SUNDRY NOTICES AND REPORTS ON WELLS

Harrington Federal 28 No. 1Y

Redwolf Production, Inc. proposes to temporarily abandon the subject well as follows: Set wireline bridge plug at 4850' and pressure test casing, to verify casing integrity. Shut in well and secure location.

**HARRINGTON FEDERAL 28 No. 1Y  
(CURRENT)**

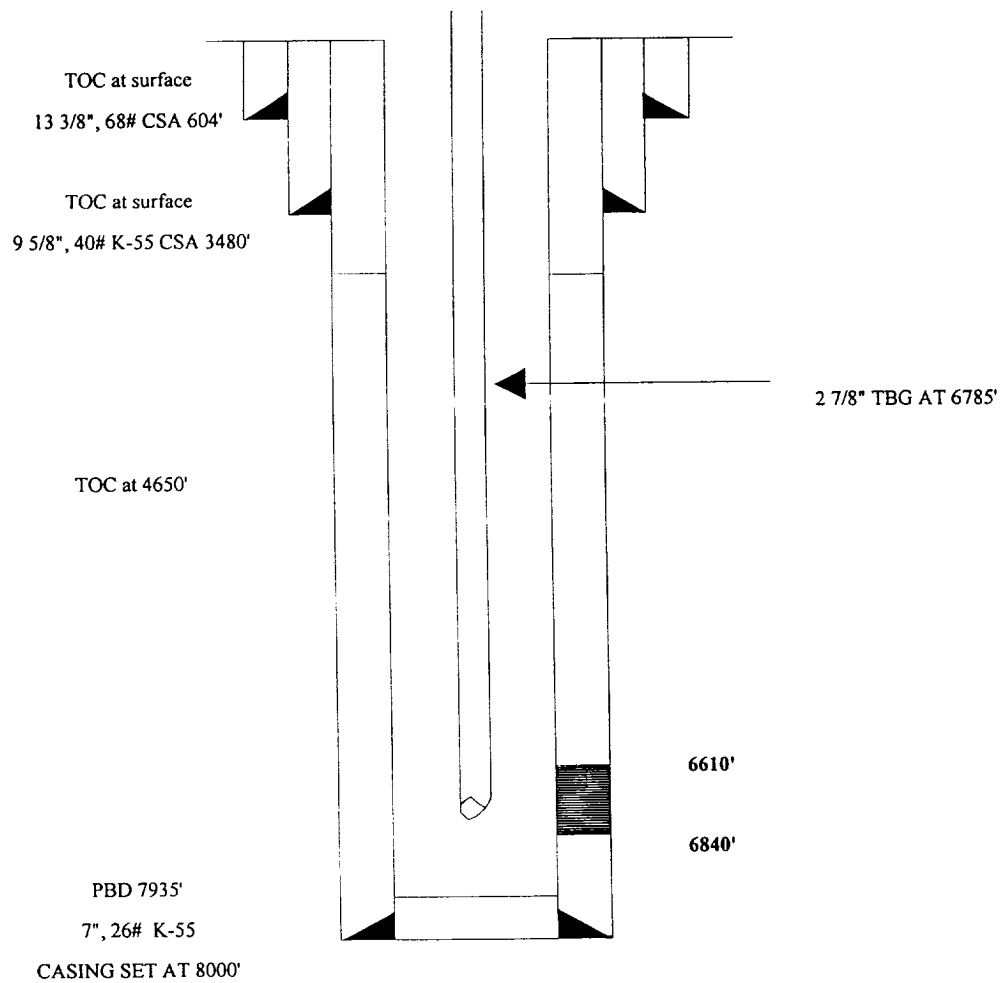
1. The bridge plug must be set within 50' to 100' of the top Mancos perforation which is at 6610'.
2. In addition to the casing mechanical integrity test, a bradenhead test is required. If the test indicates a problem exists, a remedial plan and a time frame for remediation will be submitted within 90 days from the date of the test.
3. The well bore must be filled with conditioned, non-corrosive fluid.
4. A subsequent report Sundry Notice (Form 3160-5) must be submitted within 30 days from the completion of the work.
